Final Environmental Impact Report

FLYING J TRAVEL PLAZA

Final Environmental Impact Report

State Clearinghouse No. 1999082090

FIGURE 3	EXISTING PEDRICK ROAD / I-80 WESTBOUND RAMPS INTERSECTION DESIGN	 Fehr & Peers Associates, Inc. Transportation Consultants
-----------------	---	--

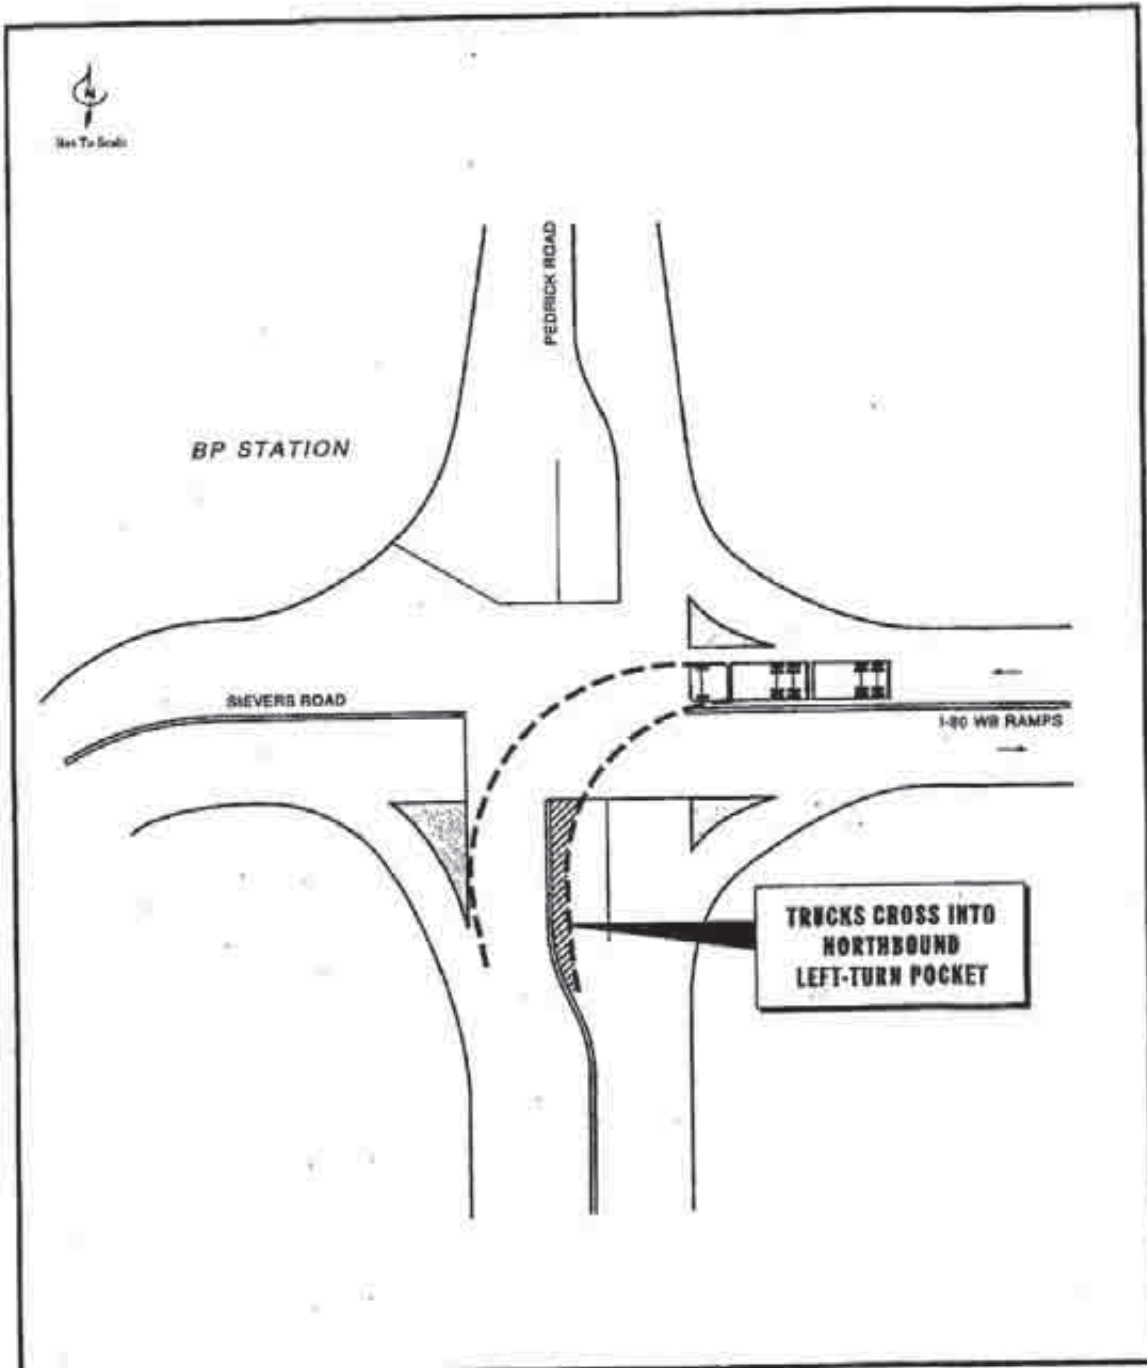
Pedrick Road. Fehr & Peers conducted a site visit and obtained geometric data at this intersection. Figure 3 illustrates this existing design deficiency by showing the lane layout and the path of a typical semi-trailer truck (i.e., a WB 50 design vehicle).

FIGURE 4

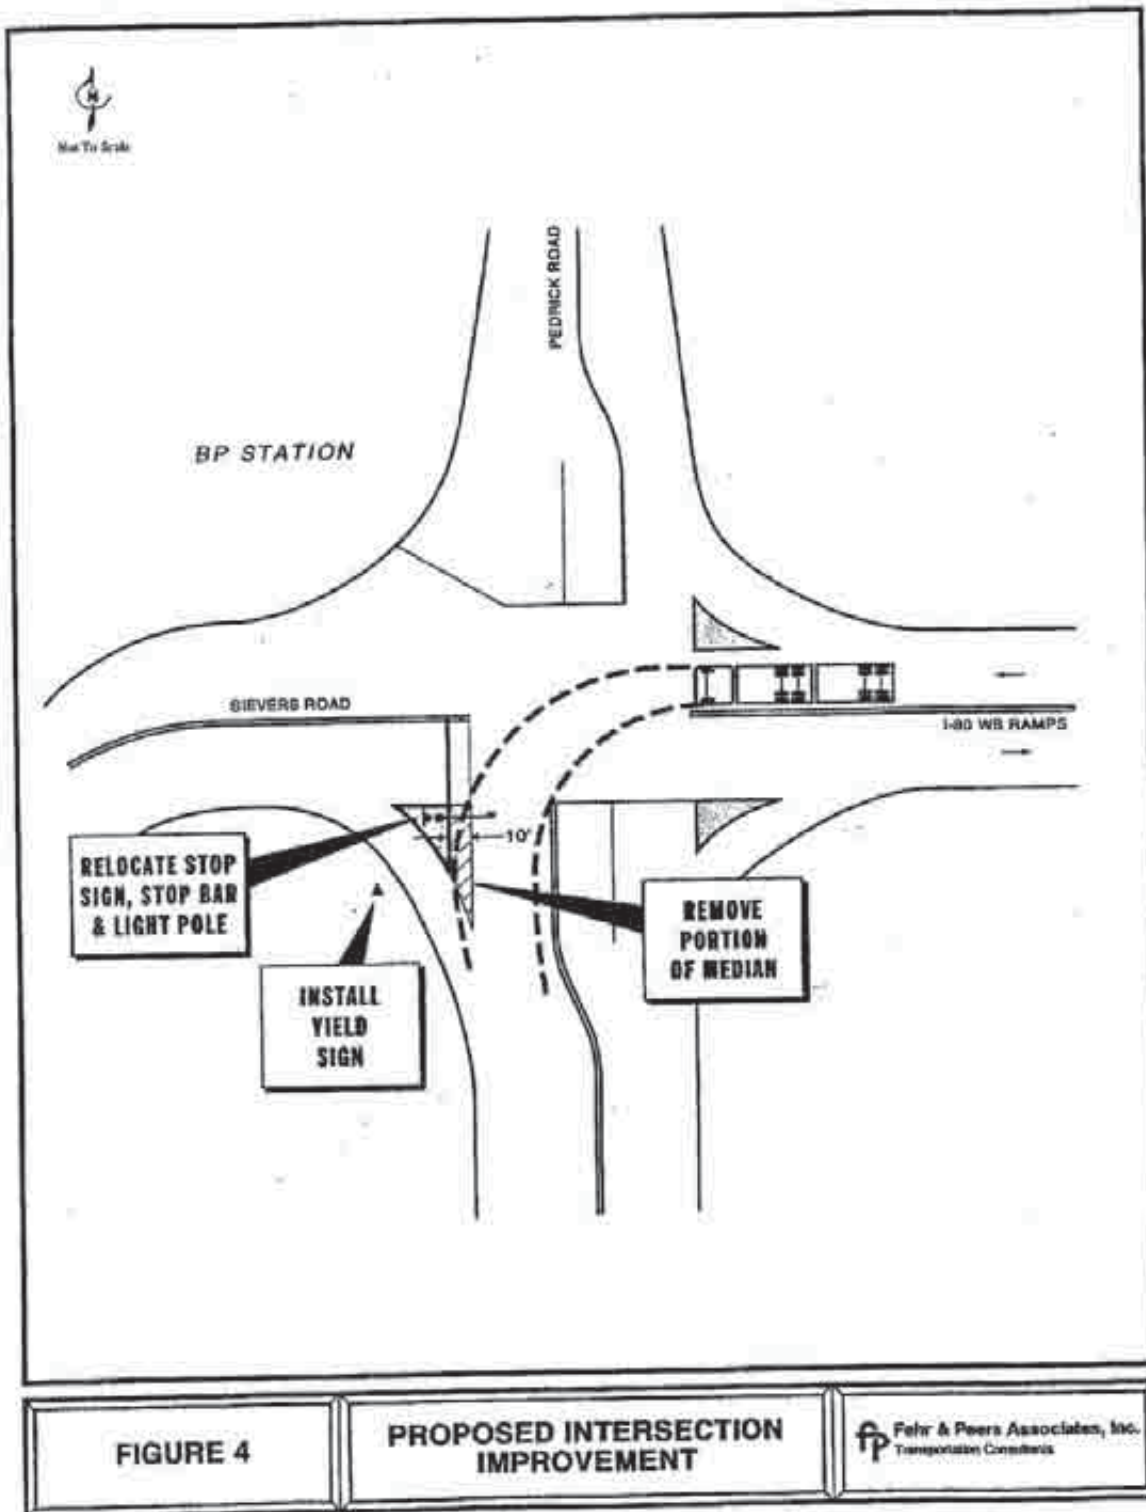
To provide an adequate turning radius, the existing intersection should be modified. Removal of approximately 10 feet of the median island in the southwest quadrant of the intersection will provide adequate width for a WB 50 design vehicle. A schematic representation of the proposed improvement is shown on Figure 4.
